## 3.0 MASTER RESPONSES TO FREQUENT COMMENTS ON THE RDEIR

Impact Sciences, Inc. 3.0-1 Scott Ranch Project Final EIR 1222.001 June 2022

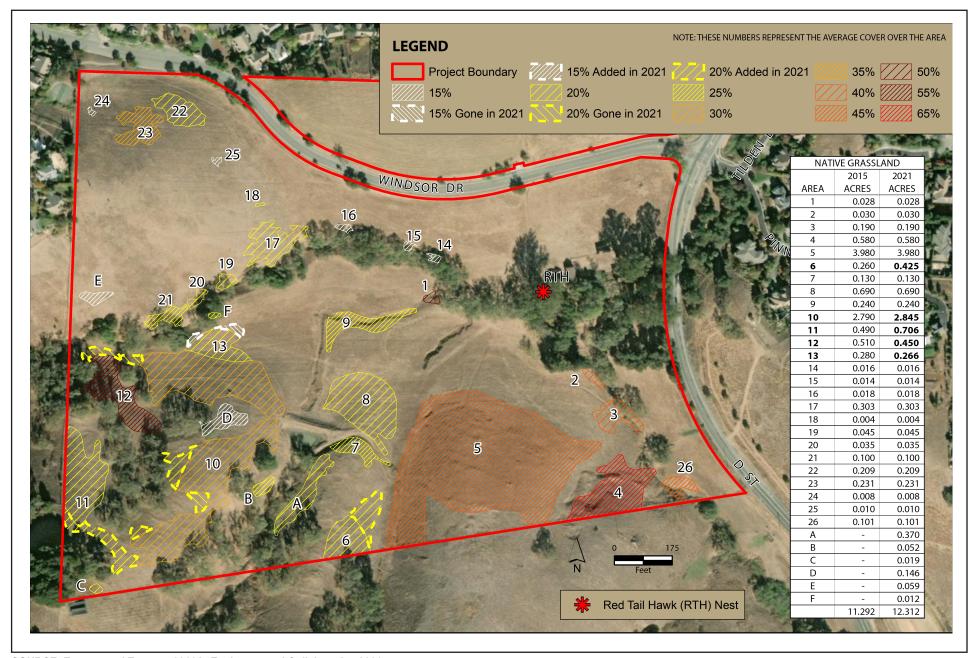
Native Grasslands. Minor shifts in the extent of native grasslands were observed during the updated mapping effort in 2021, the results of which are indicated in the Updated Figure 4.3-2, Native Grasslands, from the RDEIR presented below in this document. Stands of native grasslands receded in a few locations in the southwestern portion of the site (see stands 10, 12, and 13). However, for the most part native grassland cover expanded somewhat since mapping was done in 2015. These include expansion of several original polygons (see stands 6, 10, 11, and 13) and several new stands (see stands A through F). Between 2015 and 2021, the total acreage of native grasslands increased from 11.29 acres to 12.31 acres, a net increase of 1.02 acres. Most of these stands are located in the vicinity of other native grasslands in the southwestern portion of the site. The one exception to this was a sparse stand of native grassland (stand E) occupying about 0.06 acre on the south-facing hillside above Kelly Creek near the western edge of the site. For the most part the extent of native grasslands remained relatively stable over the past six years, although stands have expanded on the north-facing slopes in the southern portion of the site. This portion of the site where grasslands are dominant would be preserved under the proposed project as part of the 47-acre preserved open space.

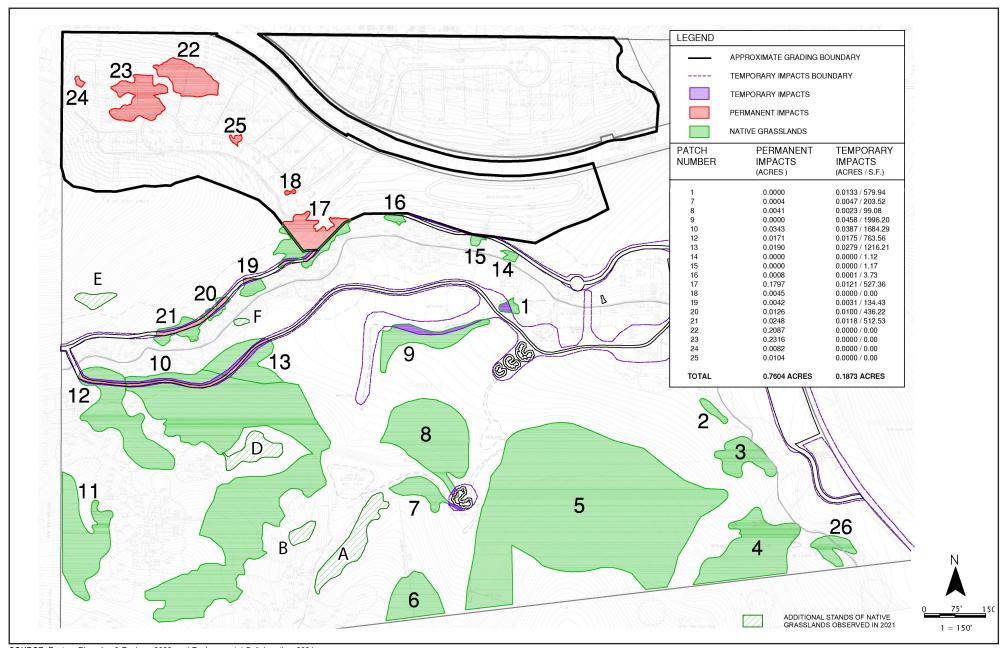
Based on the latest revisions to the Davidon (28-Lot) Residential Project component of the proposed project (described in **Chapter 2.0**, **Revised Project Description**), the acreage of impacts to existing habitat for CRLF has been further reduced from estimates contained in the RDEIR. Based on an Updated Biological Assessment (UBA) prepared by the Applicant's consulting biologist<sup>5</sup> and verified through independent review by Mr. Martin, the City's independent consulting biologist, the permanent impacts associated with the Davidon (28 Lot) Residential Project component would decrease from approximately 11.7 to 7.09<sup>6</sup> acres and the temporary impacts would decrease from approximately 5.9 to 5.76 acres. A copy of the UBA is contained in **Appendix RTC-A** of this document for review. Potential impacts from grading and other disturbance from the Putnam Park Extension Project component would remain

Permanent impacts associated with the residential component include 6.4 acres for the residences and streets, 0.48 acre for the infiltration basin located south of Windsor Drive, 0.15 acre for the upper parking lot, and 0.06 acre for fragments of the proposed trail that would be located near the upper parking lot.

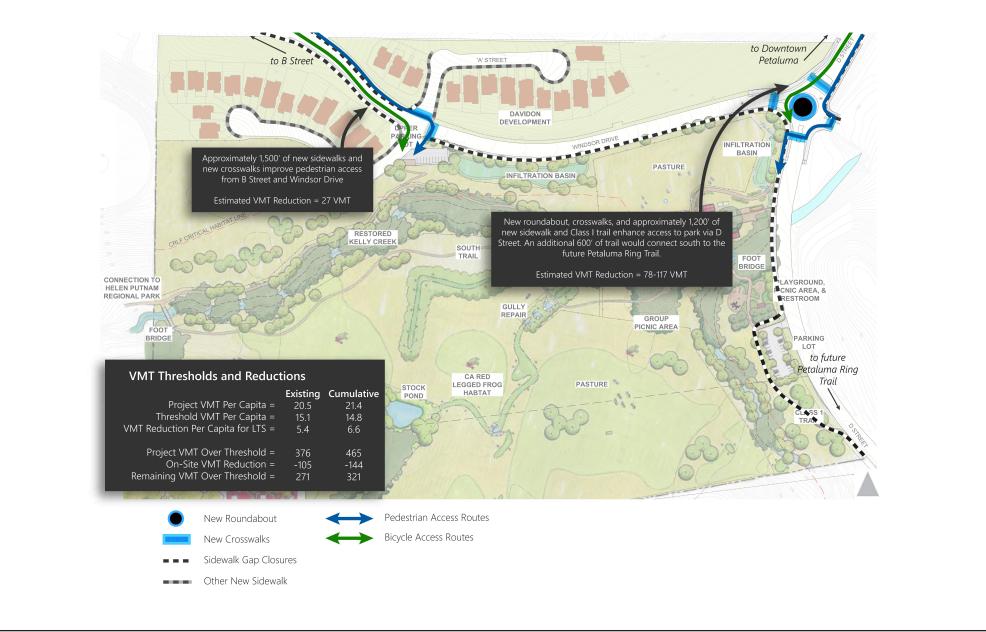
As described in Section 4.13.4.2, Vehicular Traffic Analysis of the RDEIR, and shown on Figure 3-2 under Master Response 10 – VMT Mitigation, the proposed project would add several improvements to bicycle and pedestrian access in the project area. These network changes include multi-use pathways along D Street and within the Putnam Park Extension Project component, a new roundabout and pedestrian crossing improvements at the intersection of D Street and Windsor Drive, approximately 800 feet of new sidewalk along the east side of D Street between Windsor Drive and Sunnyslope Avenue, new sidewalks along the south side of Windsor Drive to D Street, and a high-visibility crosswalk on Windsor Drive at the proposed A and B Streets. Additional improvements to pedestrian and bicycle access will be evaluated at the City engineers' discretion, as described on page 4.13-62 of the RDEIR.
